Technical Bulletin TB170

Subject: eikon Smart Relay Board (SRB) service kit

Equipment Affected: eikon

Description of Change: This bulletin outlines the procedure for replacing the SRB on all eikon models using the e4 & e5 SRB with modification to fit e3 models

(E)

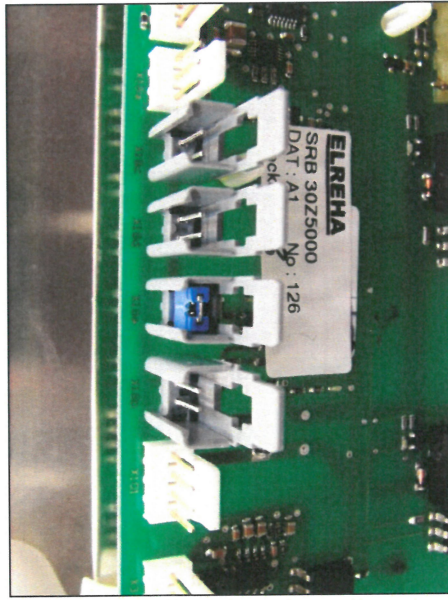
e3 Models only

Fit Jumper 30Z0369 to Header x18e. Diagram E

A

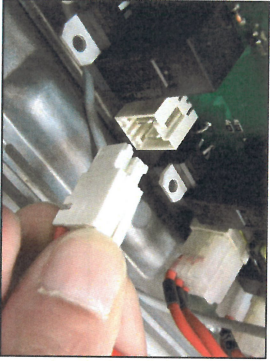
1. Process for carrying out modification / Change:
2. Isolate the oven from the mains supply and discharge the high voltage capacitors.
3. Check that all parts are in the kit provided as per list on page 1
4. Remove the lid and right hand side panel from the e3 or e4 unit or the lid and the control panel from the e5 units
5. Carefully remove the loom connectors from the SRB PCB by releasing the securing tab. See diagram A

B

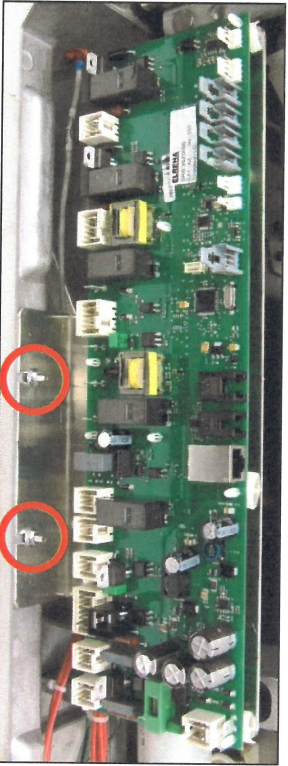
5. Remove the SRB PCB by loosening of the 2 x M4 flange nuts. Diagram B
6. Fit New SRB and tighten M4 flange nut

C

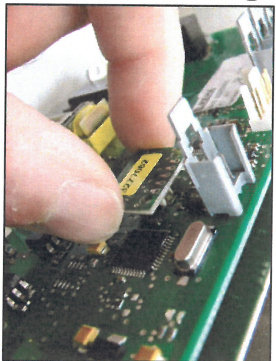
7. Remove Personality module from old SRB and fit to new SRB. Diagram C
8. Re-wire SRB. Ensure connector housing is fully home. Diagram D
